Service Letter No. 416

Heater Valve Friction Spring Installation

PA-30 Twin Comanches, Serials 30-1 to 30-224 inclusive

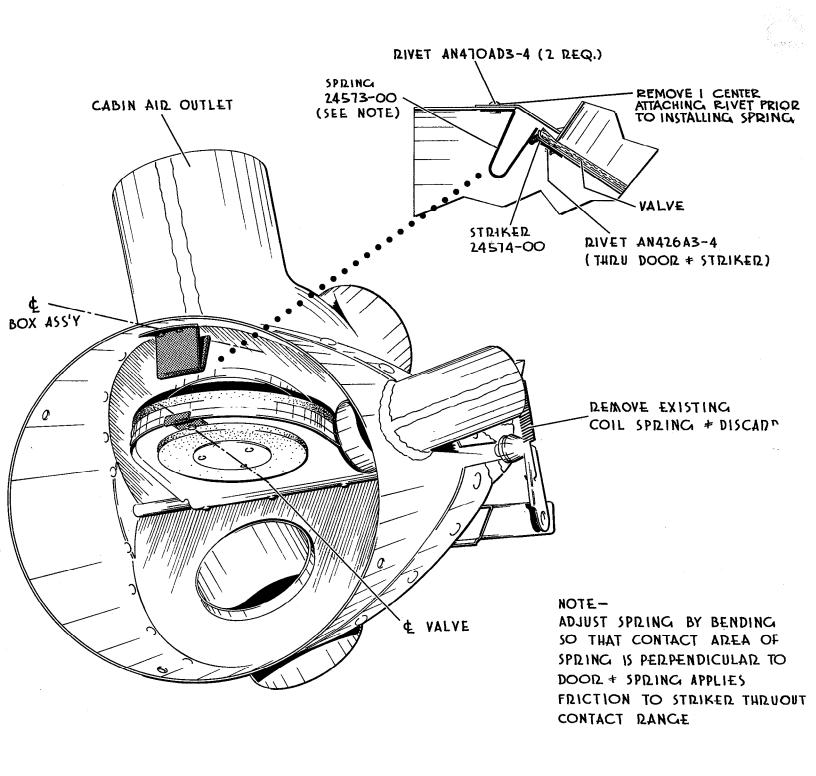
A number of reports have been received of fluttering of the heater valve in the heater plenum chamber. This generally appears between the full open or the full closed positions. To permit the control of air entering the cabin and to eliminate valve flutter, a friction spring has been installed in the heater valve.

The material to accomplish this change is available in Kit Number 756 779. It will not be necessary to submit a purchase order as this kit will be supplied on an automatic factory distribution basis.
